Subject 4 questions regarding TI DSP P/N TMS320C6701GJCA120

I have the following questions regarding the DSP p/n TMS320C6701GJCA120?

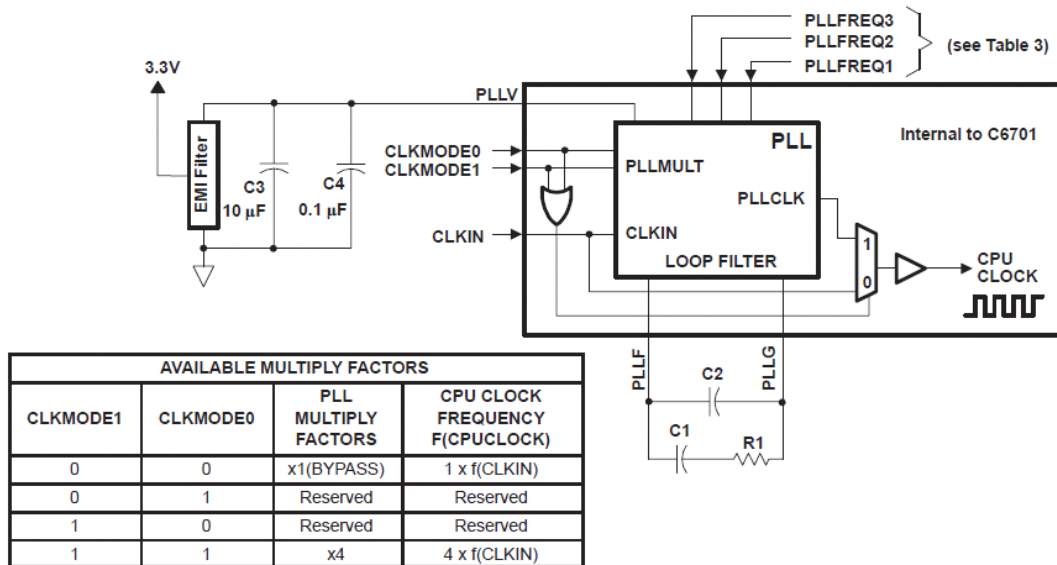
1. Regarding the below RSV signals that specify dedicated resistors, our legacy design uses 14 kilo-ohm pull up resistors for the past 8 years in production efforts. Can you please tell me if there is any impact to the DSP operation by using 14 kilo-ohm resistors instead of 20 kilo-ohm resistors?
